Access Compliance Report Public Rights-of-Way (Curb Ramps)

Intersection ID: 5758 Main Street: NEVIN_RD Cross Street: SPANISH_MOSS_LN Location: S

ADA ID: 89EE4BD02DBD Ramp Type: Perp Initial Pass/Fail: Fail Overall Compliance: No Severity Score: 1.25

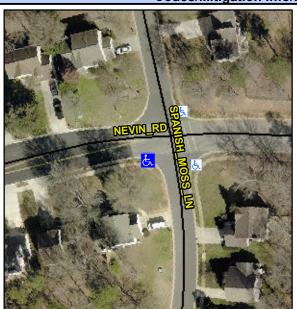
Possible Solutions:	<u>c</u>
Remove & Replace Entire Ramp.	N
	Υ
	N
	N
	N
	N
Surveyor Notes:	N
N/A	N
	N
	N
	N
PROW/ADA:	N
Not Found, R304.5.3	N
	N
	N

Field Measurements/Component Compliance						
Compliance Description		Data	Comp	oliance Description	Data	
N/A	Ramp Length (in)	96.0	Yes	Ramp Slope (%)	5.1	
Yes	Ramp Width (in)	48.0	No	Ramp XSlope (%)	3.9	
N/A	Flare Type LT	N/A	N/A	Flare Type RT	N/A	
N/A	Flare Slope LT (%)	N/A	N/A	Flare Slope RT (%)	N/A	
N/A	Flare Traversable LT?	N/A	N/A	Flare Traversable RT?	N/A	
N/A	Landing Length (in)	N/A	N/A	DWS Provided?	N/A	
N/A	Landing Width (in)	N/A	N/A	DWS Contrast?	N/A	
N/A	Landing Slope (%)	N/A	N/A	DWS Length (in)	N/A	
N/A	Landing X Slope (%)	N/A	N/A	DWS Full Width?	N/A	
N/A	Landing Curb? (Y/N)	N/A	N/A	DWS Offset (in)	N/A	
N/A	Shared Landing?	N/A				
N/A	Gutter Ponding?	N/A	N/A	Gutter Slope (%)	N/A	
N/A	Gutter Lip Ht (in)	N/A	N/A	Gutter X Slope (%)	N/A	
N/A	Painted X Walk1?	No	N/A	Painted X Walk2?	N/A	
	X Walk 1 Direction	To E		X Walk 2 Direction	N/A	
N/A	X Walk 1 Width (in)	N/A	N/A	X Walk 2 Width (in)	N/A	
	X Walk 1 Slope (%)	3.6		X Walk 2 Slope (%)	N/A
